A303 Amesbury to Berwick Down

**8.46 – Response to English Heritage objection to PRow to
Visitor Centre**

Response to English Heritage objection to PRow to Visitor Centre

Regulation Number:	Regulation 5(2)(q)
Planning Inspectorate Scheme Reference	TR010025
Application Document Reference	8.46
Author:	A303 Amesbury to Berwick Down Project Team, Highways England

Drawing Title
NMU OPTION 11
A360 TO STONEHENGE
VISITOR CENTRE
OVERVIEW

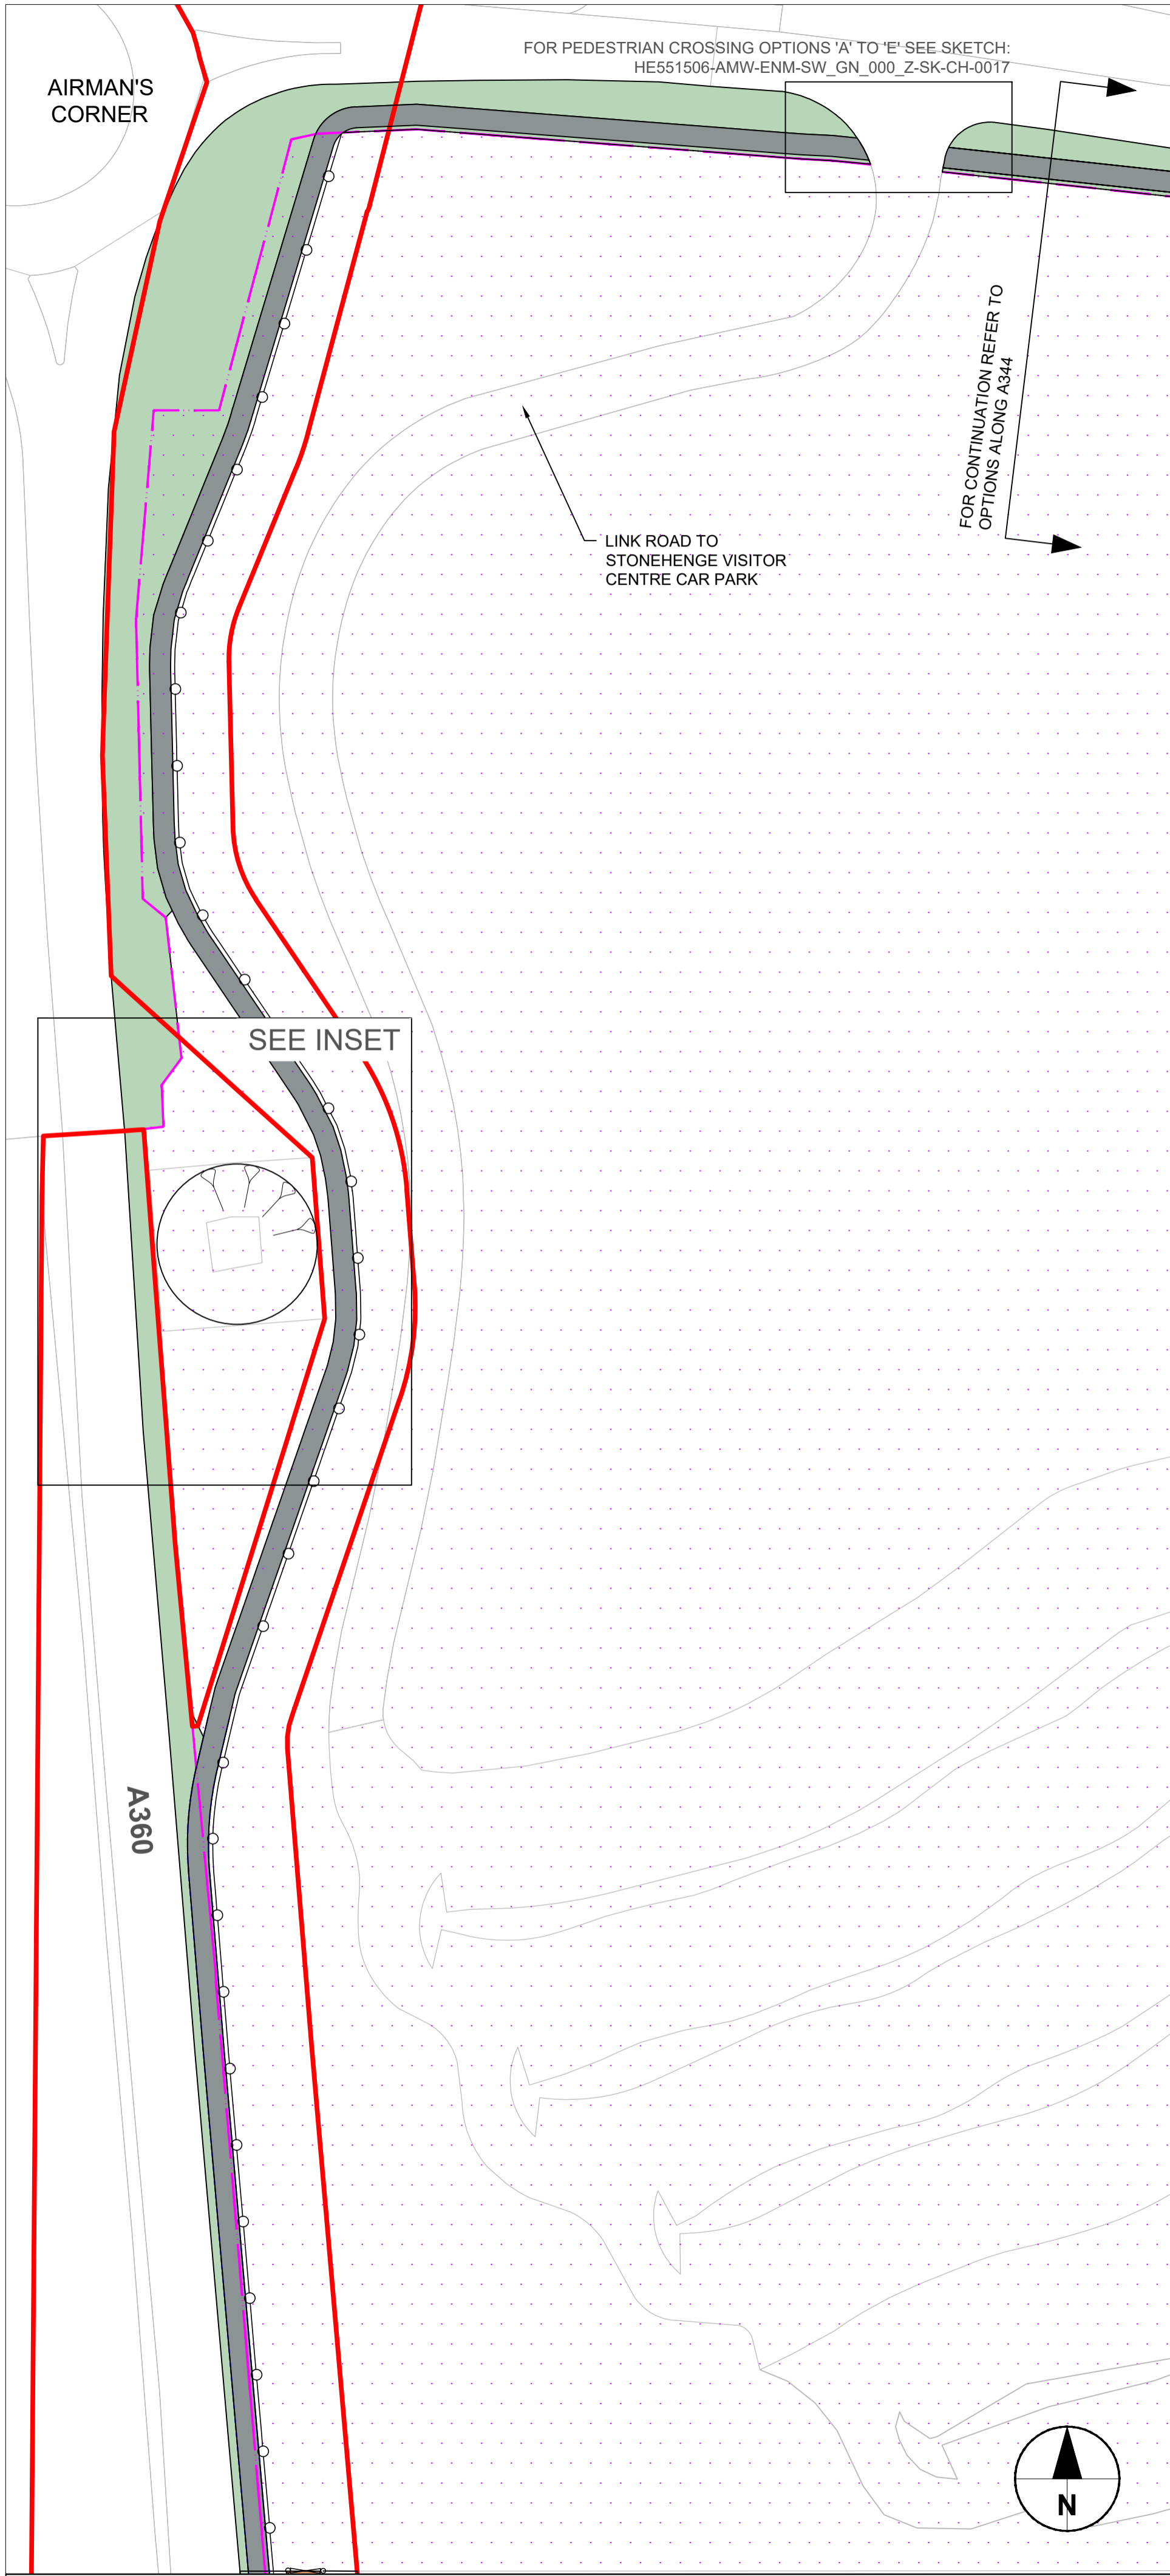
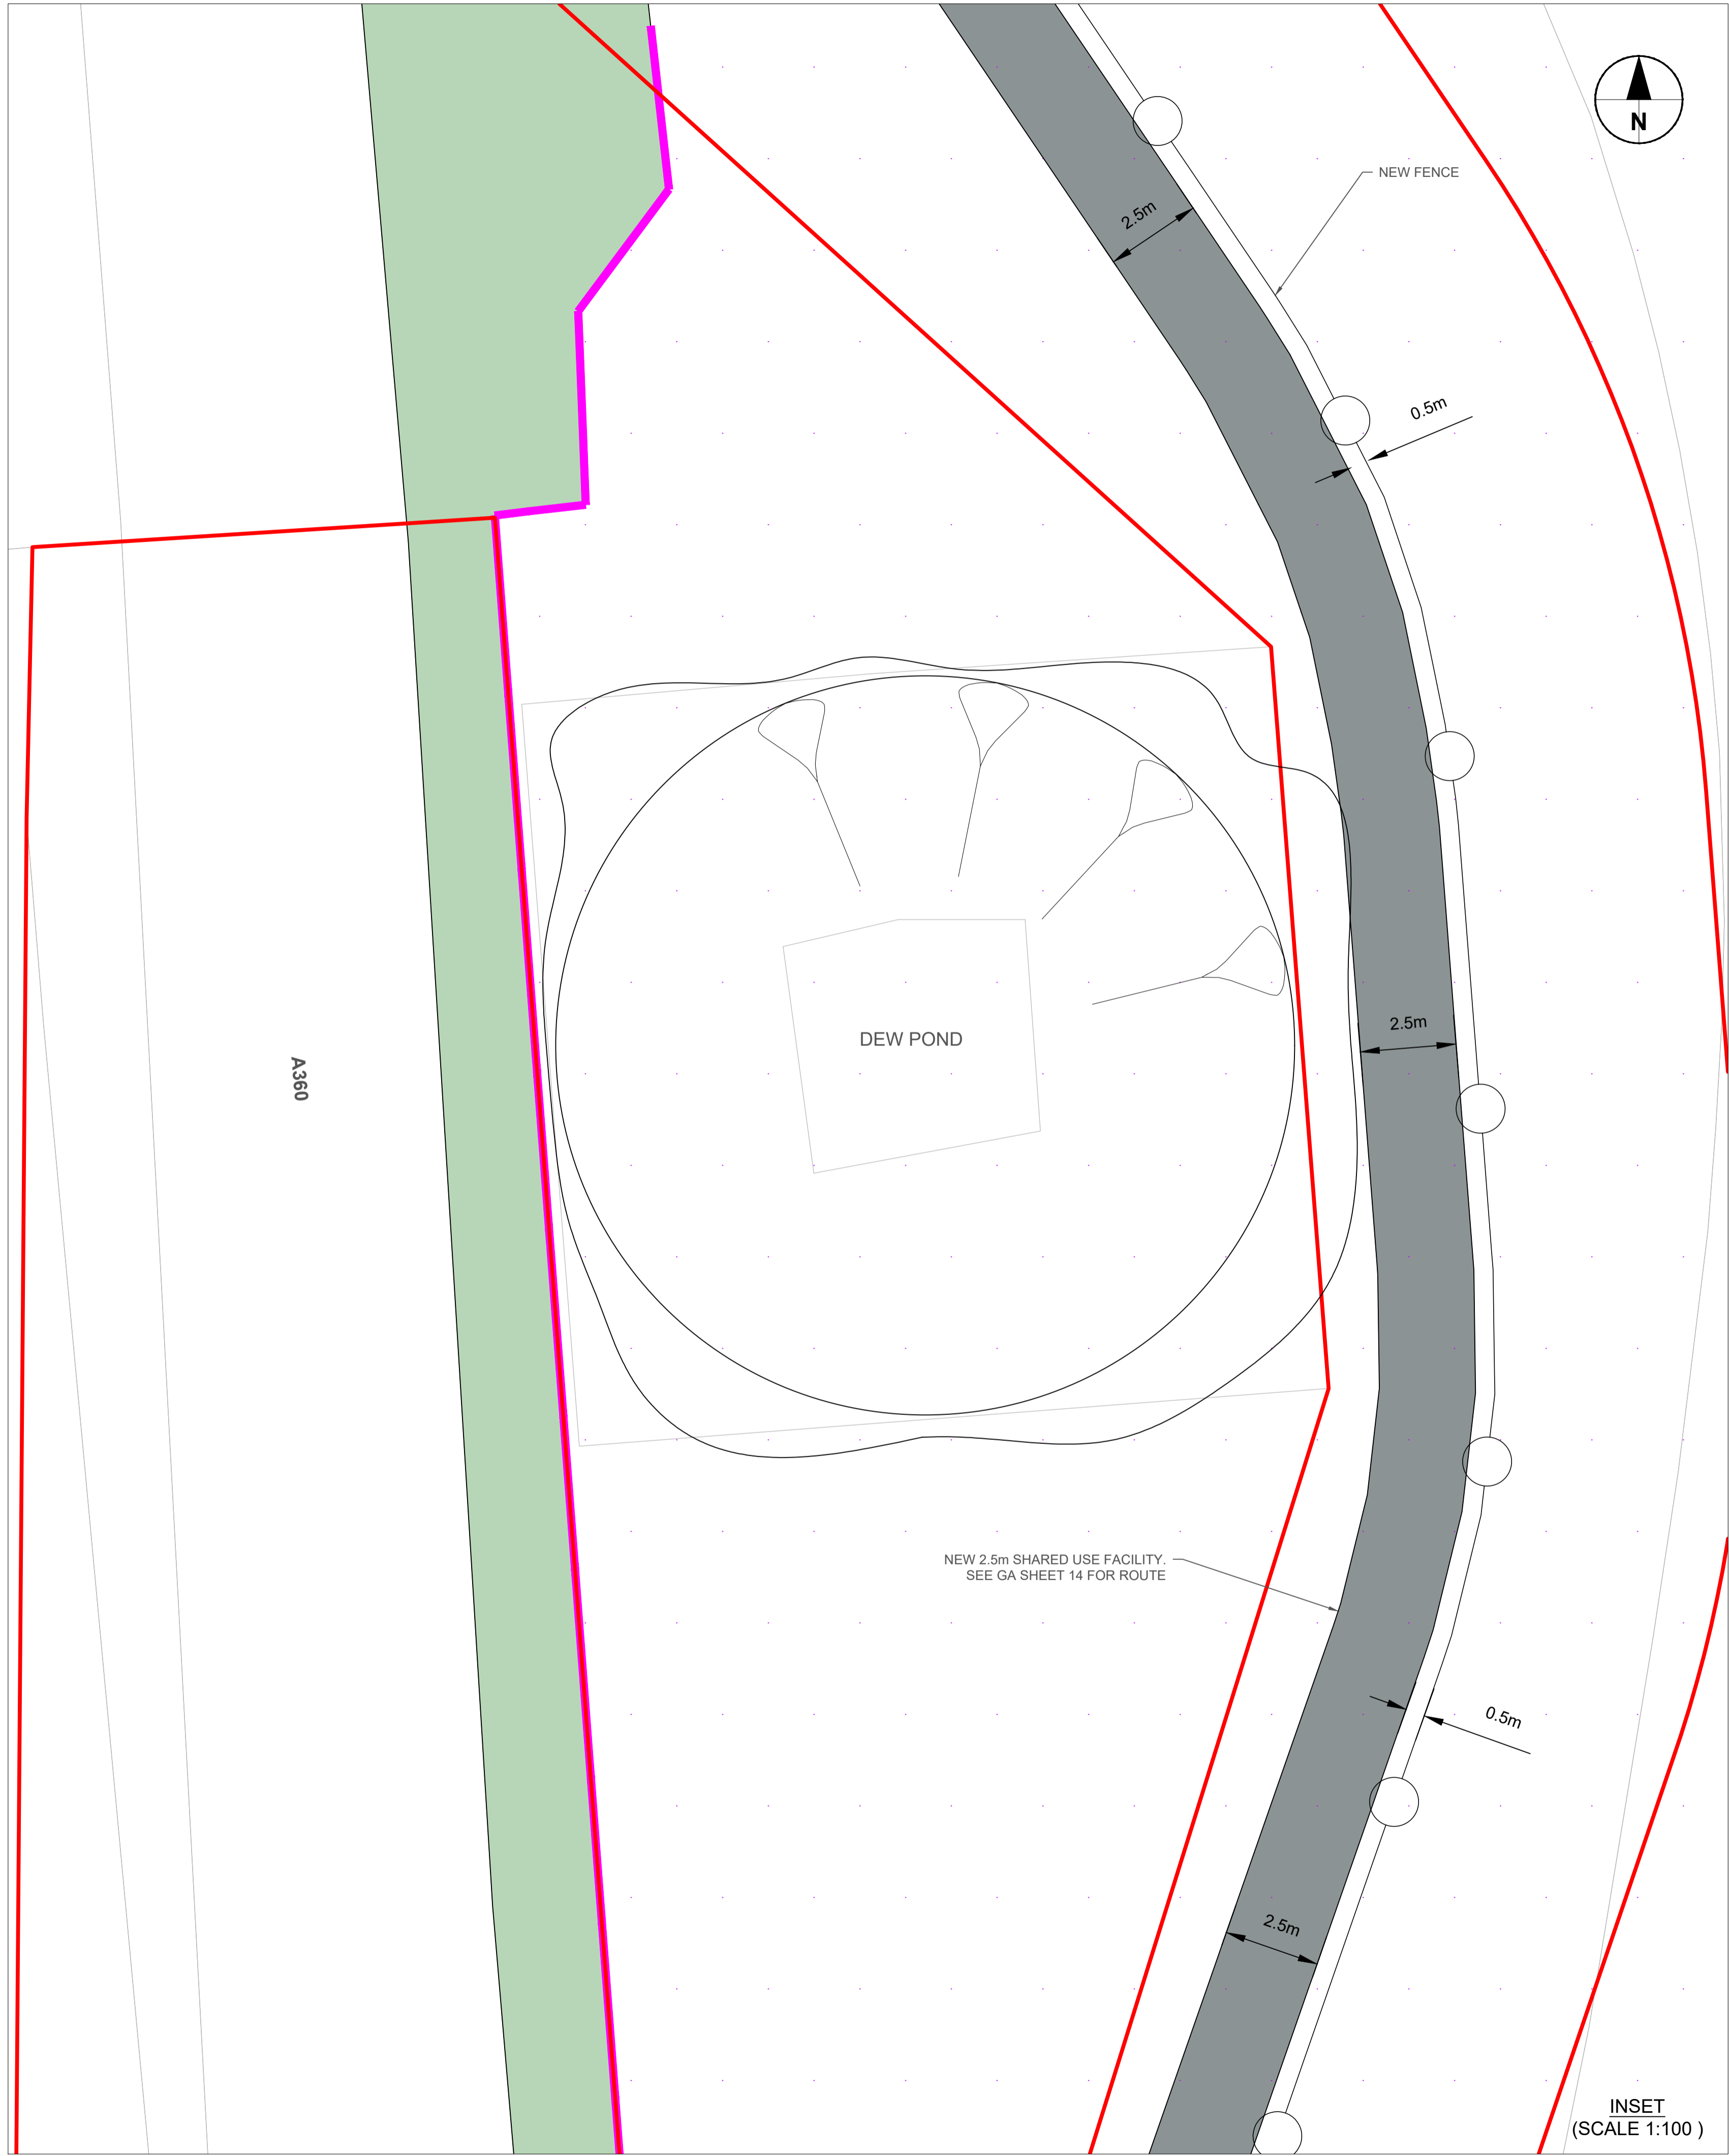
- 5.2.1 Option 11 would be similar to option 10 except that the shared-use cycleway would pass to the east of the dew pond following an alignment similar to that of the restricted byway proposed in the DCO application. A width of 2.5m would be maintained for the full length of the shared-use cycleway.
- 5.2.2 The area of land proposed to be acquired from within the Visitor Centre site for the purposes of delivering option 11 is 1,568 square metres. This is all within the current Order Limits. Depending on the option selected to extend the shared-use cycle route along the C506, further land outside the Order Limits would be required (see section 6 below).
- 5.2.3 Option 11 is shown on drawing HE551506-AMW-ENM-SW_GN_000_Z-SK-CH-0301 in Appendix 3 to this report.
